AMERICANS WITH DISABILITY
ACT (ADA) FACILITY
ASSESSMENT REPORT

Americans with Disabilities Act (ADA) Facility Barrier Report

July 2024

Bella Vista Park

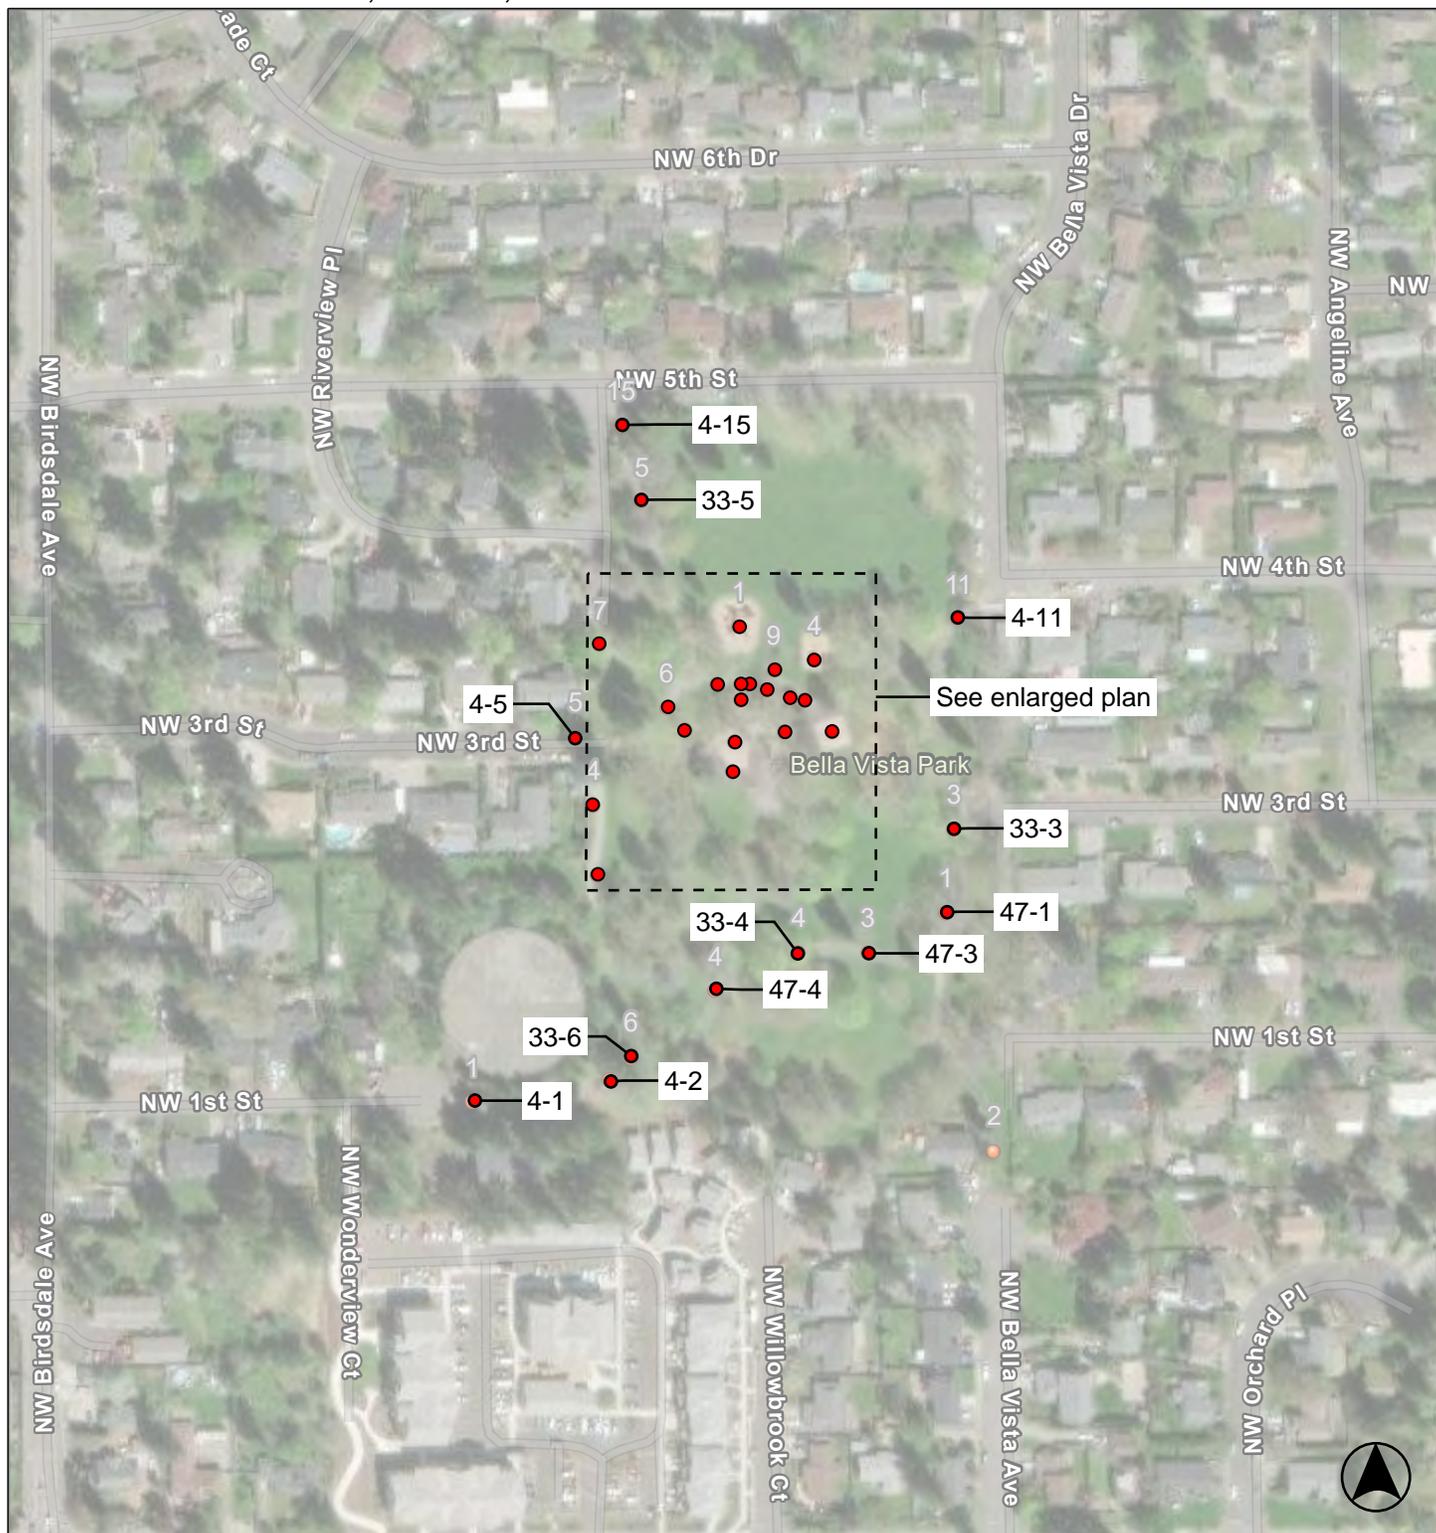
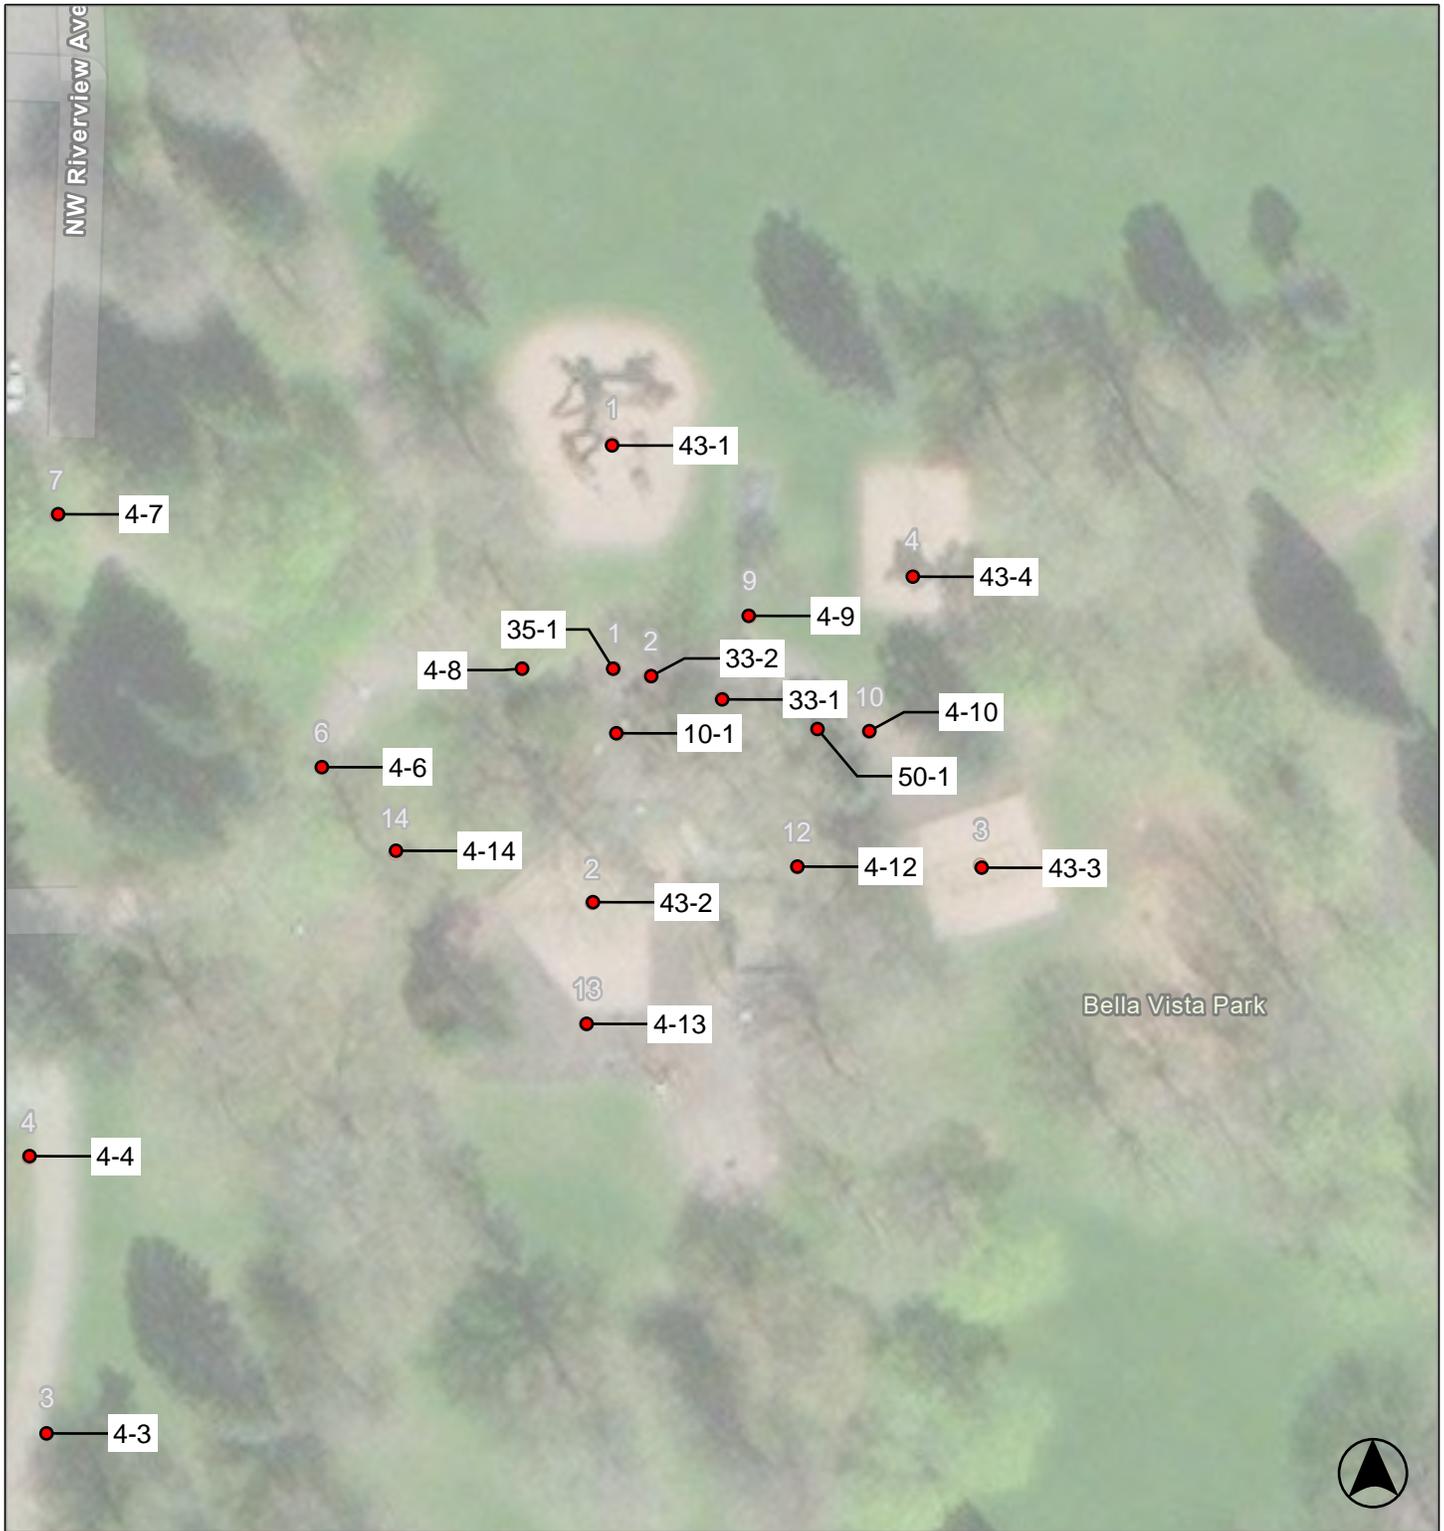
Park	
4 - 12	Walk Category: 1
Regrade surface	\$4,700
Notes: Running slope of ramp near play area is up to 23.9% for 47 linear feet (5.0% max).	
ADA: 403.3	
Other: -	
Grind or patch vertical change of grade	\$100
Notes: Surface level change is greater than 1/2" due to crack (1/4" max; up to 1/2" with a 1:2 bevel).	
ADA: 303.2, 303.3	
Other: -	
4 - 13	Walk Category: 1
Regrade surface	\$8,400
Notes: Cross slope of concrete around play area is up to 5.6% for 84 linear feet (2.0% max).	
ADA: 403.3	
Other: -	
Reduce or eliminate opening	\$300
Notes: Gap at crack in concrete is greater than 1/2" (1/2" max).	
ADA: 302.3	
Other: -	
4 - 14	Walk Category: 1
Regrade surface	\$2,000
Notes: Cross slope of concrete is up to 6.0% for 20 linear feet (2.0% max).	
ADA: 403.3	
Other: -	
4 - 15	Walk Category: 1
Regrade surface	\$6,600
Notes: Cross slope of concrete is up to 3.9%, run slope is up to 11.1% for 66 linear feet (2.0% max).

Park	
10 - 1	Drinking Fountain Category: 3
Increase or provide maneuvering or clear floor area	\$1,270
Notes: There is a 2" vertical change in level at the clear floor space of the fountain (1/2" max).	
The clear floor space in front of the fountain is 17" wide (30" min).	
ADA: 305.1, 305.2, 305.3, 305.5, 306.1	
Other: -	
Confirm water flow compliance	\$0
Notes: Water service to the drinking fountain was disconnected at the time of the assessment. Flow height and angle could not be confirmed.	
ADA: 602.3, 602.6	
Other: -	
33 - 1	Outdoor Constructed Features Category: 3
Increase or provide clear floor area	\$200
Notes: A clear ground space is not provided adjacent to the bench (36" by 48" min).	
ADA: -	
Other: ABA 1011.2.1, ABA 1011.2.3	
33 - 2	Outdoor Constructed Features Category: 3
Regrade surface	\$20
Notes: Clear ground space adjacent to the trash container has a slope of 7.5% (2.0% max).	
ADA: 305.1	
Other: ABA 1011.2.3

33 - 3	Outdoor Constructed Features Category: 3
Increase or provide clear floor area	\$200
Notes: A clear ground space is not provided adjacent to the bench (36" by 48" min).	
ADA: -	
Other: ABA 1011.2.1, ABA 1011.2.3	
33 - 4	Outdoor Constructed Features Category: 3
Increase or provide clear floor area	\$200
Notes: A clear ground space is not provided adjacent to the bench (36" by 48" min).	
ADA: -	
Other: ABA 1011.2.1, ABA 1011.2.3	
33 - 5	Outdoor Constructed Features Category: 3
Increase or provide clear floor area	\$200
Notes: A clear ground space is not provided adjacent to the bench (36" by 48" min).	
ADA: -	
Other: ABA 1011.2.1, ABA 1011.2.3

Park	
33 - 6	Outdoor Constructed Features Category: 3
Increase or provide clear floor area	\$200
Notes: A clear ground space is not provided adjacent to the bench (36" by 48" min).	
ADA: -	
Other: ABA 1011.2.1, ABA 1011.2.3	
35 - 1	Other Category: 3
Reposition controls	\$285
Notes: Operating mechanism of dog bag station is 60" above the ground (15" min to 48" max).	
ADA: 308.2, 308.2.1	
Other: -	
43 - 1	Play Equipment Area Category: 2
Improve or evaluate play area surface	\$0
Notes: Ground surface in play area is in need of maintenance and further evaluation of fall attenuation surface is recommended.	
ADA: 1008.2.6.1, 1008.2.6.2	
Other: -	
43 - 2	Play Equipment Area Category: 2
Improve or evaluate play area surface	\$0
Notes: Ground surface in play area is in need of maintenance and further evaluation of fall attenuation surface is recommended.	
No accesible route to the slide landing.	
ADA: 1008.2.6.1, 1008.2.6.2

Other: -	
43 - 3	Play Equipment Area Category: 2
Improve or evaluate play area surface	\$0
Notes: Ground surface in play area is in need of maintenance and further evaluation of fall attenuation surface is recommended.	
ADA: 1008.2.6.1, 1008.2.6.2	
Other: -	
Regrade or replace ramp	\$540
Notes: The ramp into the play area has a 10.3% slope (8.33% max).	
ADA: 240.2.1	
Other: -

Park	
43 - 4 Play Equipment Area	Category: 2
Improve or evaluate play area surface	\$0
Notes: Not surveyed due to closure.	
ADA: 1008.2.6.1, 1008.2.6.2	
Other: -	
47 - 1 Trails	Category: 2
Install sign	\$250
Notes: A trail sign is not provided.	
ADA: -	
Other: ABA 1017.10	
Provide resting interval in path of travel	\$2,540
Notes: A resting interval is required at 30 feet.	
ADA: -	
Other: ABA 1017.4	
Regrade surface	\$4,200
Notes: Trail slope is between 8.3 - 10% for 70 feet (2% max. for concrete, asphalt or boards or 5% max. for all other surfaces).	
ADA: -	
Other: ABA 1017.7.2	
47 - 2 Trails	Category: 2
Regrade surface	\$2,400
Notes: Running slope of trail is up to 13% for 40 linear feet (10 feet max when running slope between 10% and 12.5%).	
ADA: -	
Other: ABA 1017.7.1	
47 - 3 Trails	Category: 2
Regrade surface	\$4,140
Notes: Up to 5% cross slope for 69 feet (2% max. for concrete, asphalt or boards or 5% max. for other surfaces).

Nadaka Nature Park

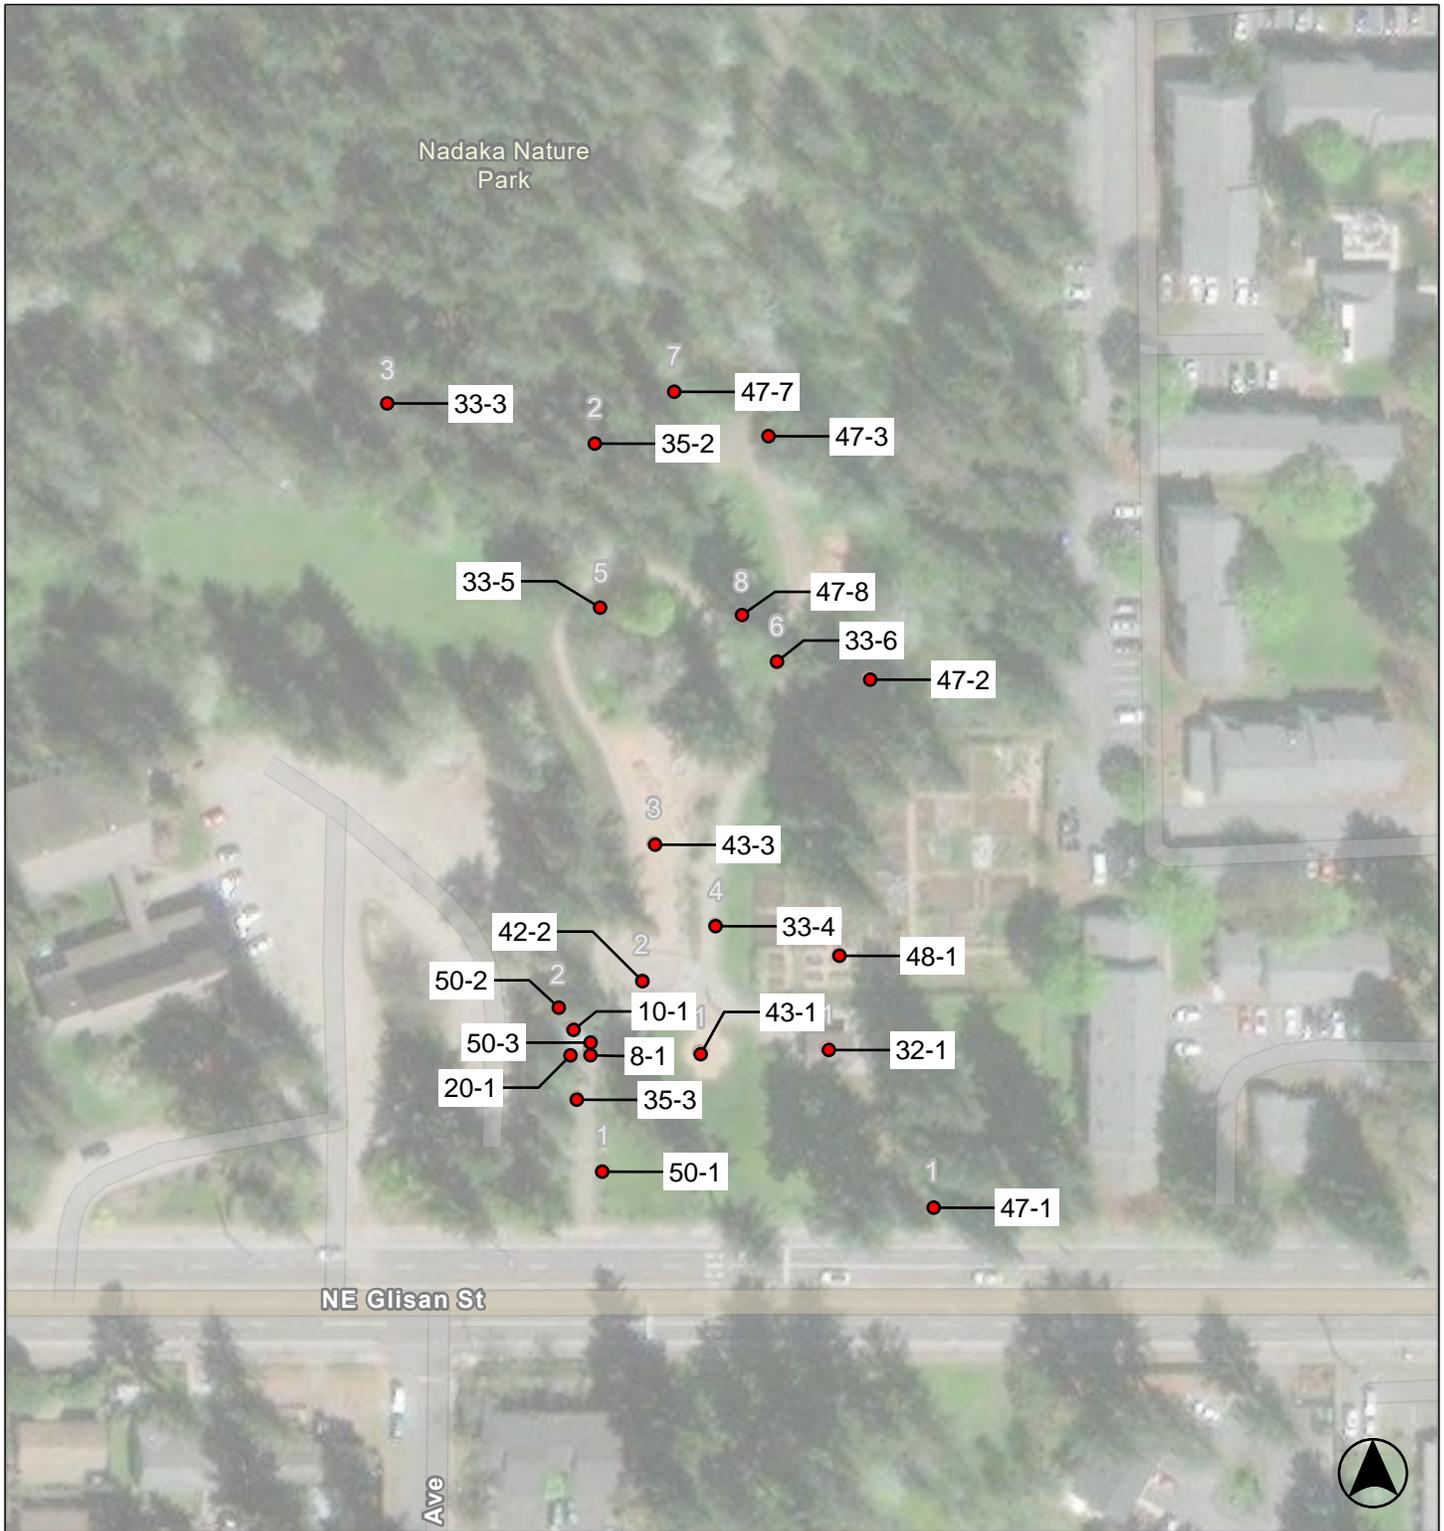
ADA: -	
Other: ABA F245.2.2	
33 - 1	Outdoor Constructed Features Category: 3
Increase or provide clear floor area	\$200
Notes: A clear ground space is not provided adjacent to the bench (36" by 48" min).	
ADA: -	
Other: ABA 1011.2.1, ABA 1011.2.3

Park	
33 - 2	Outdoor Constructed Features Category: 3
Increase or provide clear floor area	\$200
Notes: A clear floor space is not provided at the trash container opening (36" by 48" min forward approach).	
ADA: -	
Other: ABA 1011.2	
Provide an accessible route	\$2,560
Notes: An accessible route to the fixed trash/recycling container is not provided. Route is 32 linear feet over grass from to the container. (48" wide minimum path of travel constructed with an accessible surface)	
ADA: -	
Other: ABA F206.2.2	
33 - 3	Outdoor Constructed Features Category: 3
Increase or provide clear floor area	\$200
Notes: A clear ground space is not provided adjacent to the bench (36" by 48" min).	
ADA: -	
Other: ABA 1011.2.1, ABA 1011.2.3	
Provide an accessible route	\$1,600
Notes: An accessible route to the fixed bench is not provided. Route is 20 linear feet over dirt and grass from route to bench.	
ADA: -	
Other: ABA F206.2.2

33 - 4	Outdoor Constructed Features Category: 3
Increase or provide clear floor area	\$400
Notes: A clear ground space is not provided adjacent to the bench (36" by 48" min). (x2)	
ADA: -	
Other: ABA 1011.2.1, ABA 1011.2.3	
33 - 5	Outdoor Constructed Features Category: 3
Provide an accessible route	\$2,000
Notes: An accessible route to the fixed bench is not provided. Route is 25 linear feet over grass to the bench.	
ADA: -	
Other: ABA F206.2.2

Park	
33 - 6	Outdoor Constructed Features Category: 3
Increase or provide clear floor area	\$200
Notes: A clear floor space is not provided at the trash container opening (36" by 48" min forward approach). Surface is not stable or firm.	
ADA: -	
Other: ABA 1011.2	
35 - 1	Other Category: 3
Increase or provide maneuvering or clear floor area	\$200
Notes: Clear floor space of the dog bag station is not provided (30" by 48" min).	
ADA: 305.2, 305.3, 305.5	
Other: -	
35 - 2	Other Category: 3
Increase or provide maneuvering or clear floor area	\$200
Notes: Clear floor space of the dog bag station is not provided (30" by 48" min).	
ADA: 305.2, 305.3, 305.5	
Other: -	
Provide an accessible route	\$1,200
Notes: An accessible path of travel is not provided to the dog bag station. Surface is grass and dirt for 15 linear feet (firm, stable, and slip resistant).	
ADA: 206.2	
Other: -	
35 - 3	Other Category: 3
Reposition controls	\$285

Park	
43 - 3 Play Equipment Area	Category: 3
Improve or evaluate play area surface	\$0
Notes: Ground surface in play area is in need of maintenance and further evaluation of fall attenuation surface is recommended.	
ADA: 1008.2.6.1, 1008.2.6.2	
Other: -	
Provide an accessible route	\$160
Notes: Gaps in ramp to play area are 1" wide (1/2" maximum). X2 gaps	
ADA: 1008.2.5.1	
Other: -	
47 - 1 Trails	Category: 3
Provide a firm, stable and slip resistant surface	\$1,480
Notes: The trail surface is not firm and stable. Trail surface is woodchips, dirt, and debris for 37 linear feet.	
ADA: -	
Other: ABA 1017.2	
47 - 2 Trails	Category: 3
Provide a firm, stable and slip resistant surface	\$6,800
Notes: The trail surface is not firm and stable. Trail surface is woodchips, dirt, and debris for 170 linear feet.	
ADA: -	
Other: ABA 1017.2	
47 - 3 Trails	Category: 3
Provide a firm, stable and slip resistant surface	\$8,400

Notes: The trail surface is not firm and stable. Trail surface is woodchips, dirt, and debris for 210 linear feet.	
ADA: -	
Other: ABA 1017.2	
47 - 4 Trails	Category: 3
Provide a firm, stable and slip resistant surface	\$8,600
Notes: The trail surface is not firm and stable. Trail surface is woodchips, dirt, and debris for 215 linear feet.	
ADA: -	
Other: ABA 1017.2

Park	
47 - 5	Trails Category: 3
Provide a firm, stable and slip resistant surface	\$4,600
Notes: The trail surface is not firm and stable. Trail surface is woodchips, dirt, and debris for 115 linear feet. The run slope at the north park entrance is 11% at the transition to the street.	
ADA: - Other: ABA 1017.2	
47 - 6	Trails Category: 3
Provide a firm, stable and slip resistant surface	\$2,600
Notes: The trail surface is not firm and stable. Trail surface is woodchips, dirt, and debris for 65 linear feet.	
ADA: - Other: ABA 1017.2	
47 - 7	Trails Category: 3
Provide a firm, stable and slip resistant surface	\$5,040
Notes: The trail surface is not firm and stable. Trail surface is woodchips, dirt, and debris for 126 linear feet.	
ADA: - Other: ABA 1017.2	
47 - 8	Trails Category: 3
Provide a firm, stable and slip resistant surface	\$1,760
Notes: The trail surface is not firm and stable. Trail surface is woodchips, dirt, and debris for 44 linear feet.

ADA: - Other: ABA 1017.2	
48 - 1	Equivalent Facilitation Consideration Category: 1
EQUIVALENT FACILITATION CONSIDERATION	\$0
Notes: Provide route through the community garden with a stable and firm surface that is 48" wide and clear. Current surface is woodchips.	
ADA: - Other: -	
50 - 1	Universal Design Recommendations Category: 5
Increase or provide clear space	\$0
Notes: Provide a clear floor space for approach to the informational sign. Consider providing a larger text size, tactile information, and/or audio options for visitors with visual disabilities.	
ADA: - Other: -

Park	
50 - 2	Universal Design Recommendations Category: 5
Increase or provide clear space	\$0
Notes: Provide a clear floor space for approach to the informational sign. Consider providing a larger text size, tactile information, and/or audio options for visitors with visual disabilities.

ADA: -	
Other: -	
50 - 3	Universal Design Recommendations Category: 5
Increase or provide clear space	\$0
Notes: Shelter reservation list/bulletin board may not be legible to a person with visual disabilities. Consider providing a larger text size, tactile information, and/or audio options for visitors with visual disabilities. A QR code to the reservations webpage, such as the one at Red Sunset Park, may be a good option.	
ADA: -	
Other: -
